# OAM Rx State Machine Corner Case

July 15, 2019

## Modified Figure 149-24:

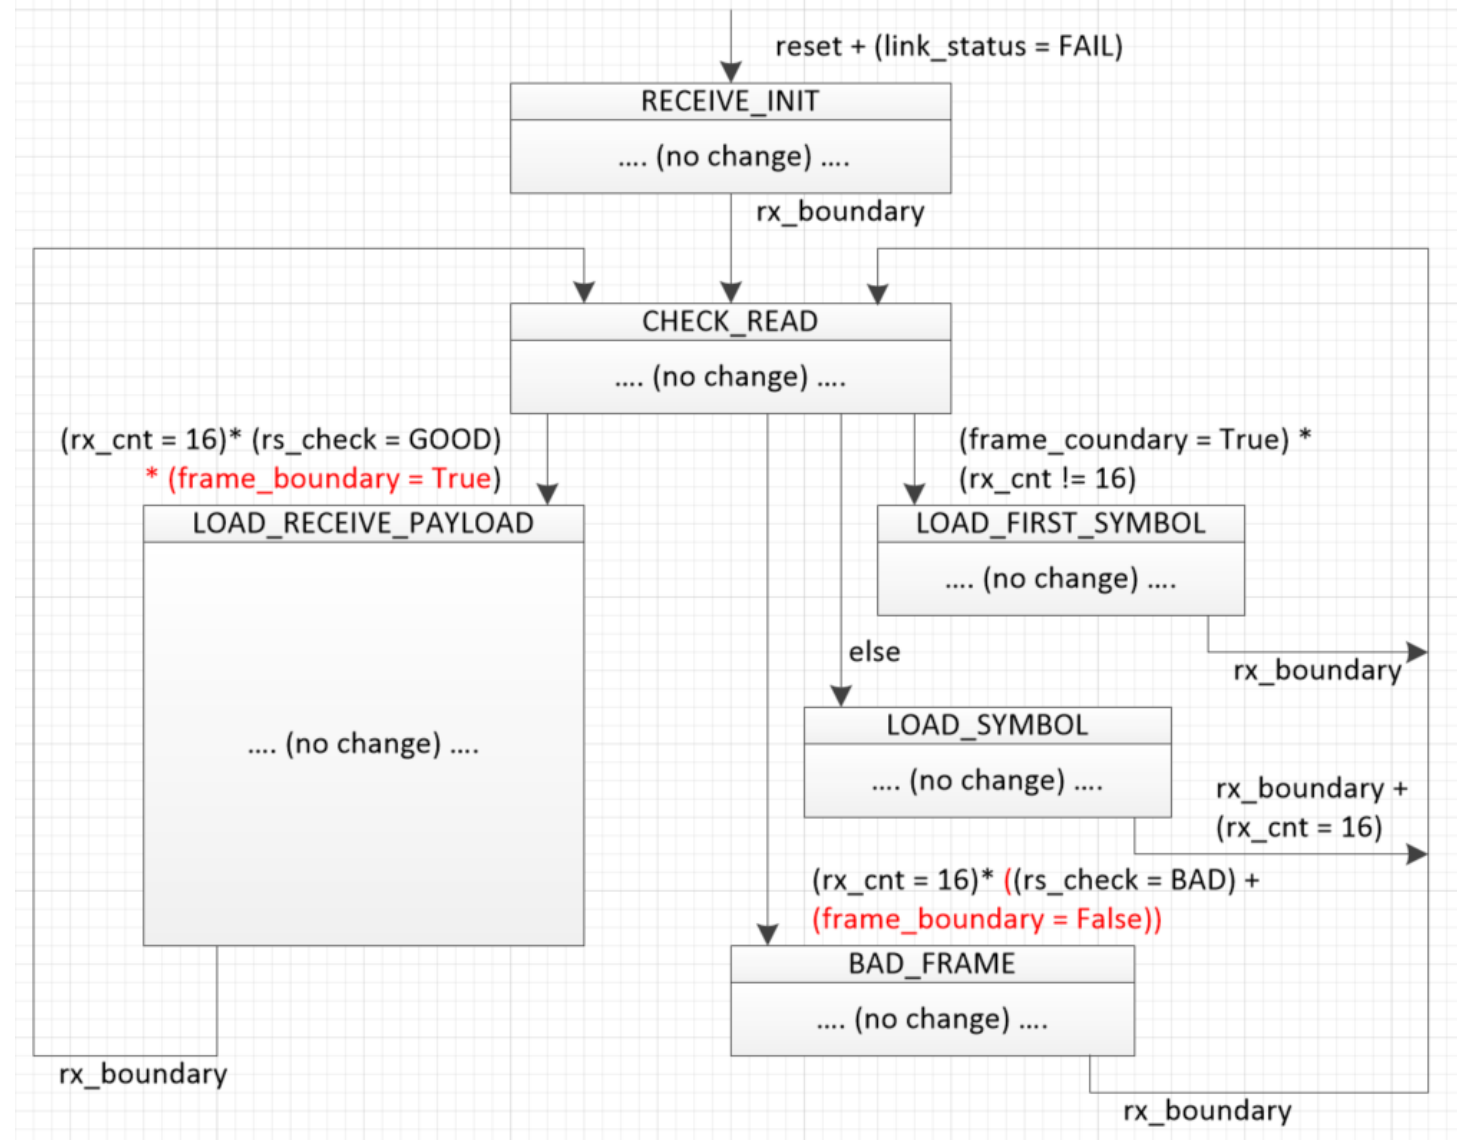
# Issue with Figure 149-24 in D2.0

- Assume OAM frame\_boundary is not found yet, and rx\_cnt is currently out of sync.
- Assume the PHY enters LPI, and rs\_check=GOOD (RS parity checked) for the first several OAM symbols when rx\_cnt reaches 16.
- In this case, the OAM Rx state machine enters the “LOAD\_RECEIVE\_PAYLOAD” state by mistake.

- In 149.3.9.4.6, page 136, line 26, Figure 149-24, make the changes as highlighted in **RED**
